1 Introduction and background

Transport for New South Wales (TfNSW; formerly Roads and Maritime Services) proposes to build the M12 Motorway between the M7 Motorway at Cecil Hills and The Northern Road at Luddenham (the project), over a distance of about 16 kilometres.

1.3 Overview of proposed changes

Figure 2-1 Key features of the amended project

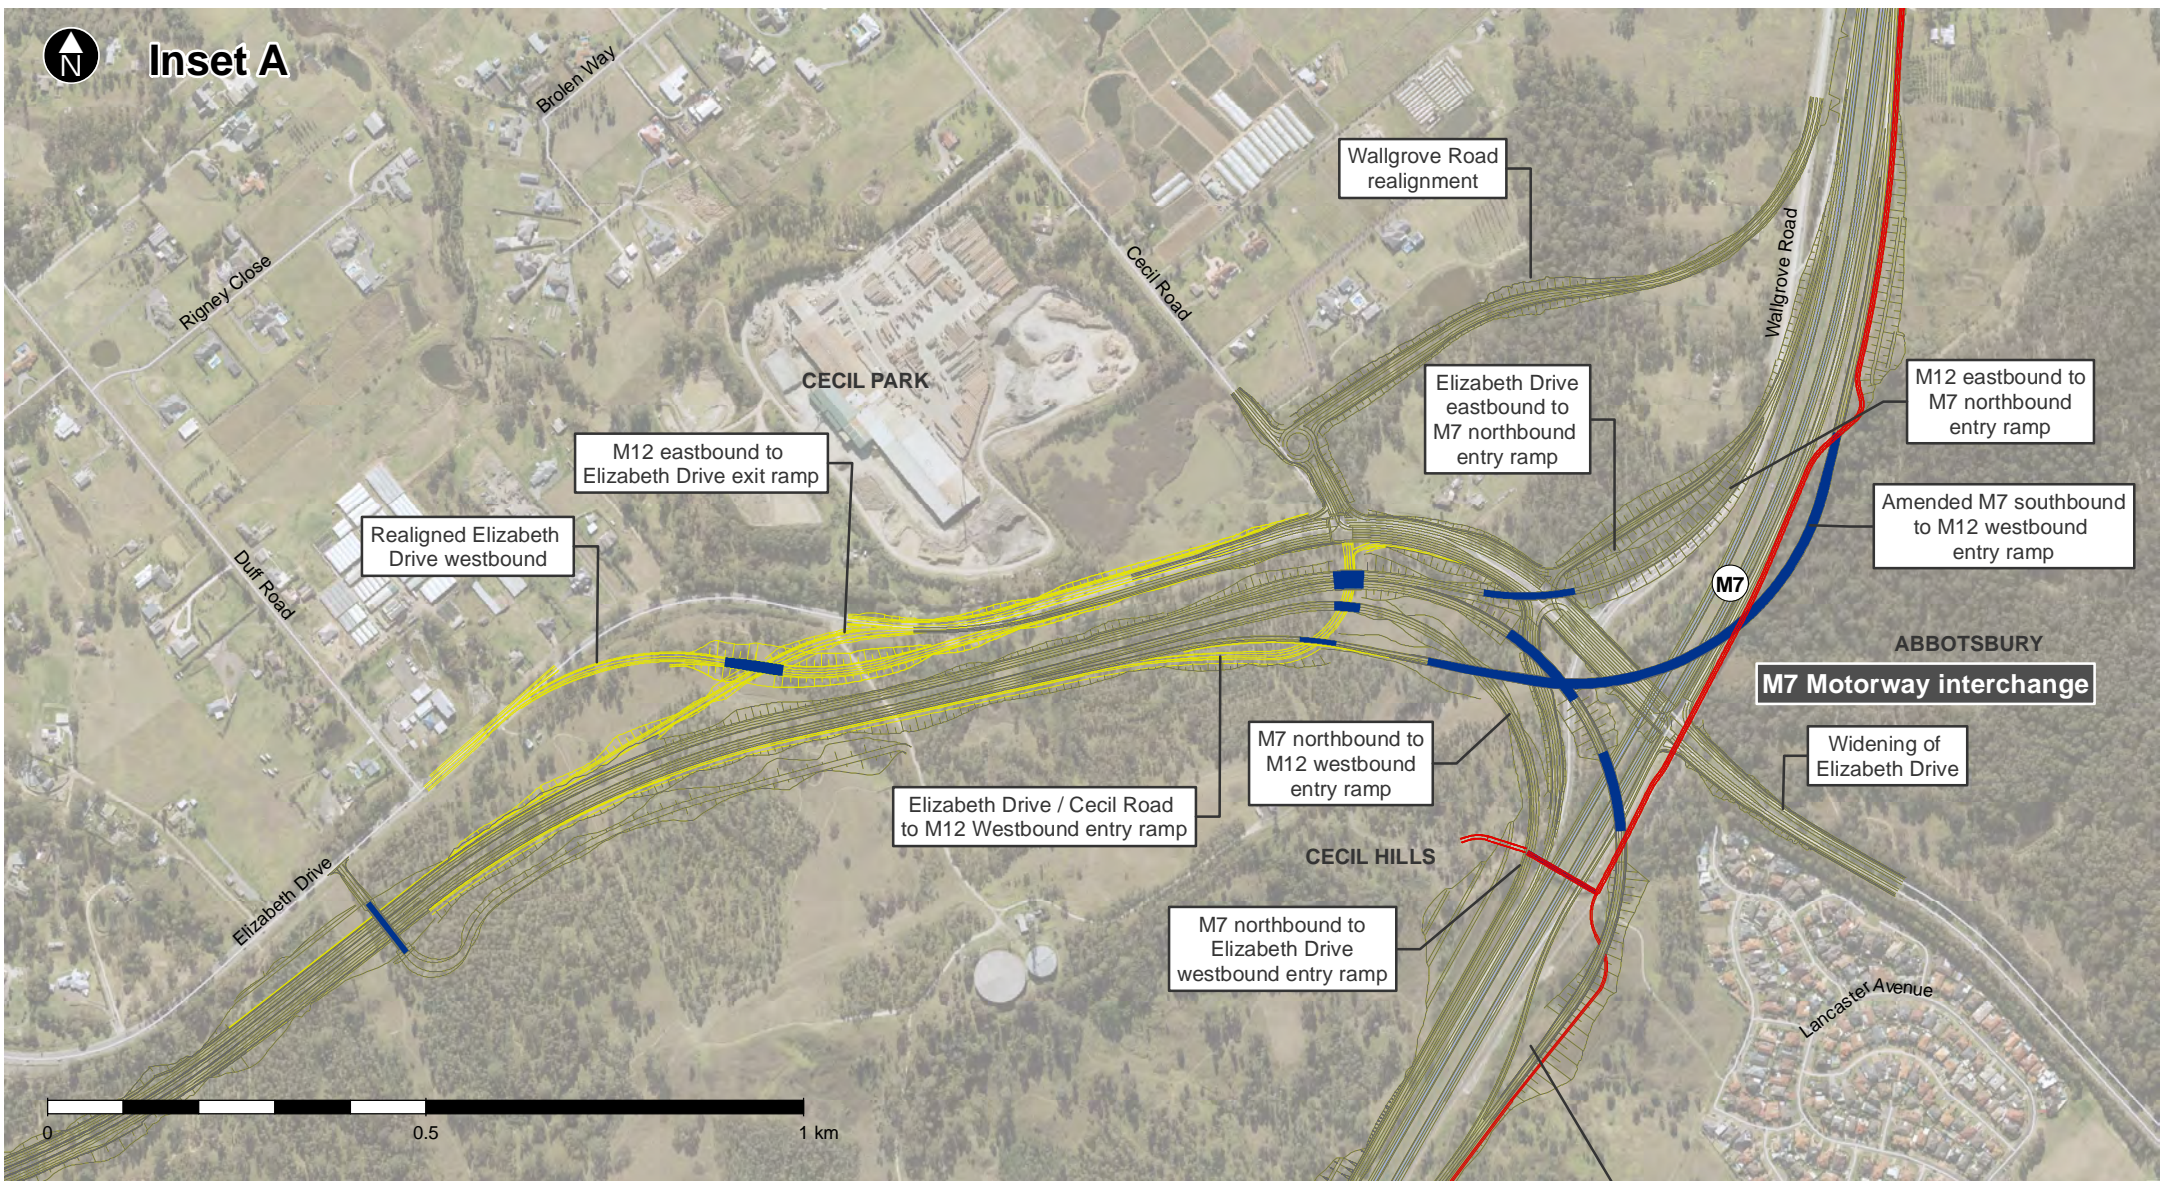
The key features of the amended project are listed below. Where the description of the proposed amended project key features differs from the description listed in the EIS, those changes are shown in **bold** text:

- **Two new signalised intersections from Elizabeth Drive into the Western Sydney International Airport, with provisions for future connection to potential developments to the north**

- **Widening of Elizabeth Drive under the M7 Motorway and approaches**
 - Realignment of Clifton Avenue over the M12 Motorway, with associated adjustments to nearby property access

- Relocation of Salisbury Avenue cul-de-sac, on the southern side of the M12 Motorway
 - **Realignment of Wallgrove Road to connect to Cecil Road, including a connection between Elizabeth Drive and Wallgrove Road via Cecil Road with a signalised intersection with Elizabeth Drive**
